TRANS/WP.29/951
8 August 2003

World Forum for Harmonization of Vehicle Regulations (WP.29)

DRAFT SUPPLEMENT 2 TO REGULATION No. 113

(Headlamps emitting a symmetrical passing beam)

EXAMPLES OF ARRANGEMENT OF APPROVAL MARKS

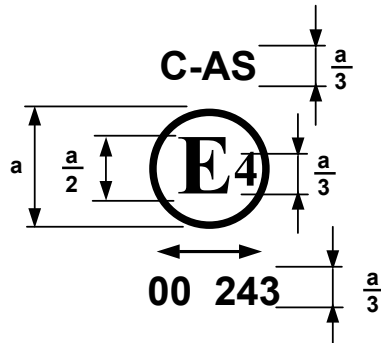
Annex 2, amend to read:

$a \geq 5$ mm for Class A headlamp

$a \geq 8$ mm for Class B, C and D headlamp

Figure 11

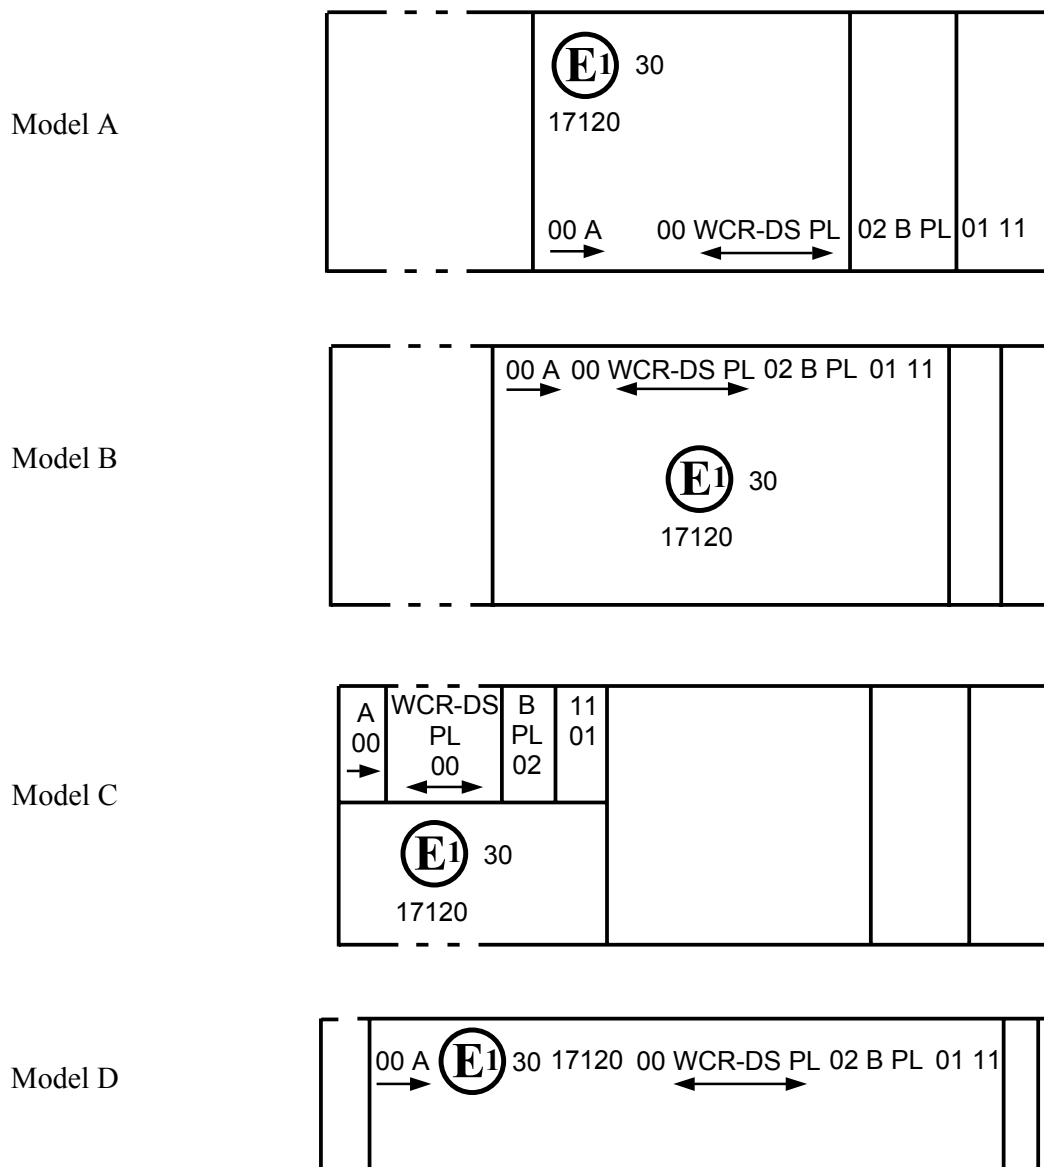
Simplified marking for grouped, combined or reciprocally incorporated lamps

Note: The four examples above correspond to a lighting device bearing an approval mark comprising:
A front position lamp approved in accordance with Regulation No. 50 in its original form (00),

A headlamp, Class D, with a passing beam and a driving beam with a maximum intensity comprised between 86 250 and 101 250 candelas (as indicated by the number 30), approved in accordance with the requirements of this Regulation in its original form (00) and incorporating a lens of plastic material,

Figure 12

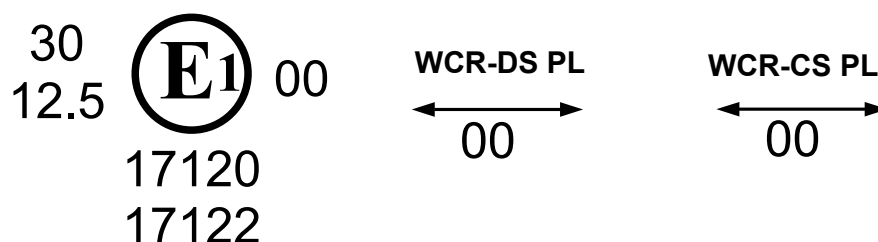
Lamp reciprocally incorporated with a headlamp

The above example corresponds to the marking of a lens of plastic material intended to be used in different types of headlamps, namely:

Either A headlamp, Class D, with a passing and a driving beam with a maximum luminous intensity comprised between 86 250 and 101 250 candelas (as indicated by the number 30), approved in Germany (E1) in accordance with the requirements of this Regulation in its original form (00), which is reciprocally incorporated with a front position lamp approved in accordance with Regulation No. 50 in its original form (00);

Or A headlamp, Class C, with a passing beam and a driving beam with a maximum luminous intensity comprised between 33 750 cd and 45 000 cd (as indicated by the number 12.5), approved in Germany (E1) in accordance with the requirements of this Regulation in its original form (00), which is reciprocally incorporated with the same front position lamp as above;

Figure A

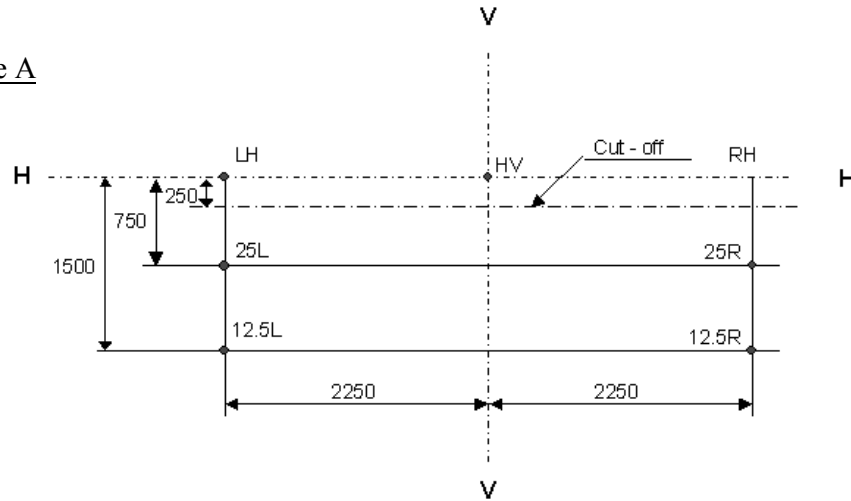
Annex 3, amend to read:

MEASURING SCREEN
for Class A headlamps
(Dimensions in mm with screen at 25 m distance)

Figure B

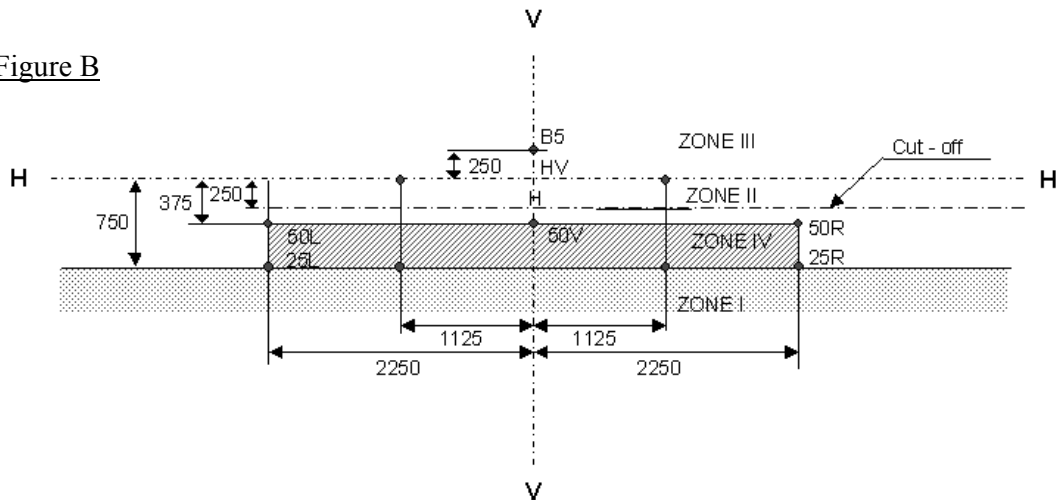
MEASURING SCREEN
for Class B headlamps
(Dimensions in mm with screen at 25 m distance)

Figure C

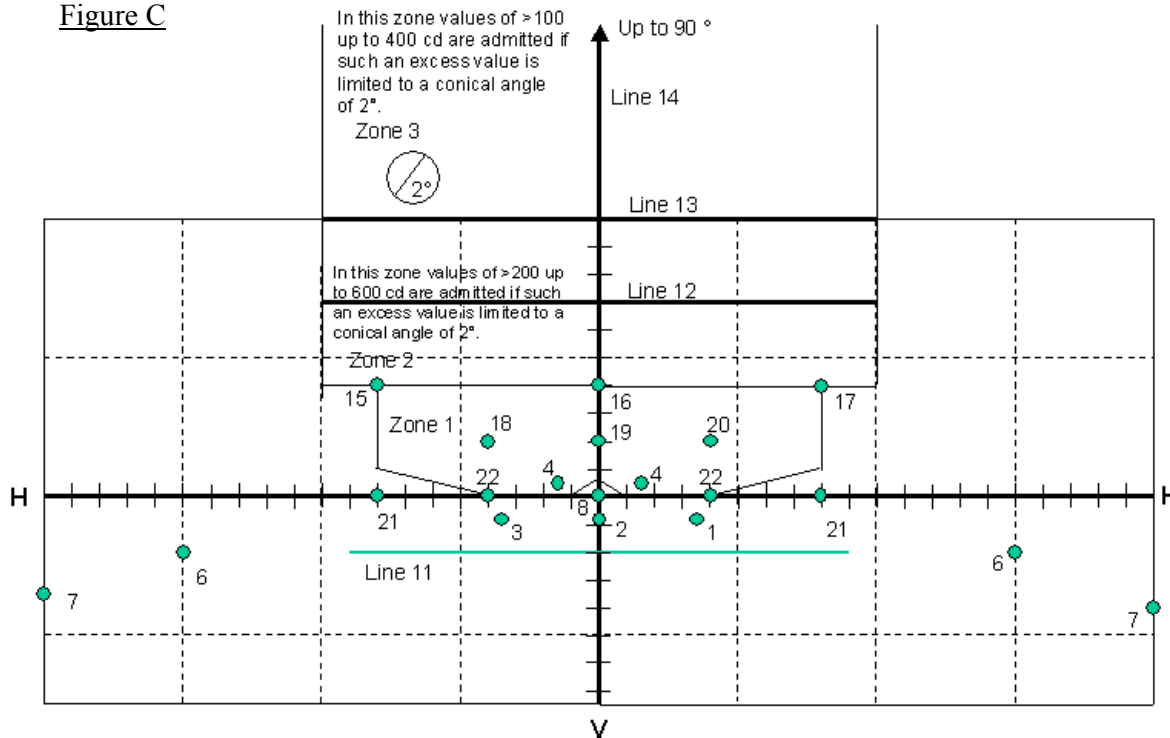
MEASURING SCREEN
for Class C and D headlamps
(Dimensions in mm with screen at 25 m distance)

Figure D
Primary Driving Beam

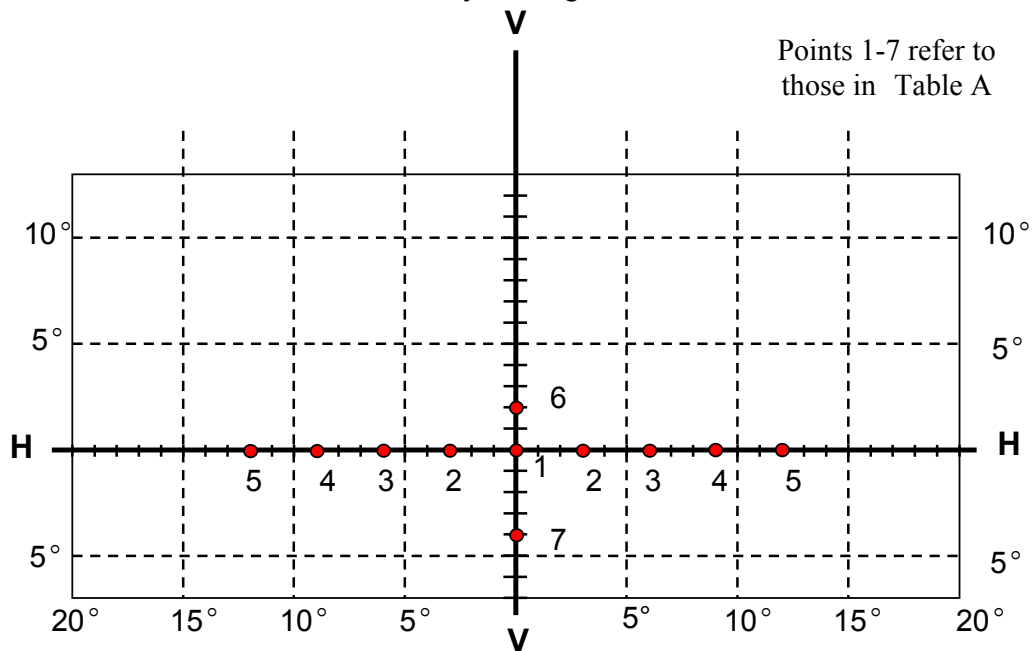
Table A - Primary high beam headlamp

Refer to Figure D for details of test point positions

Figure E
Secondary Driving

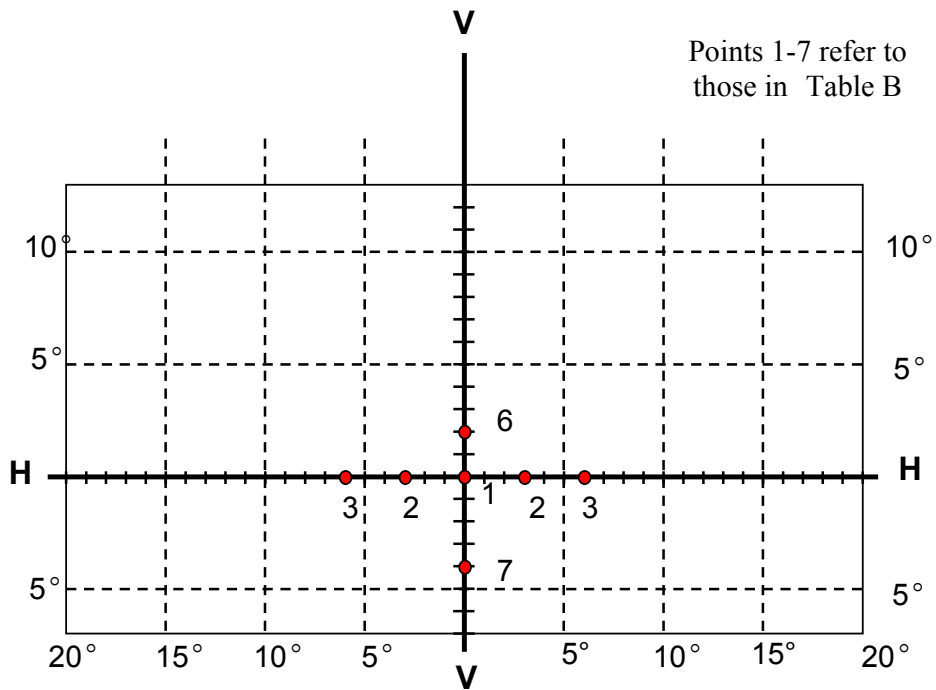
Table B -Secondary high beam headlamp operated with a harmonized passing beam headlamp or a primary driving beam headlamp

Refer to Figure E for details of test point positions
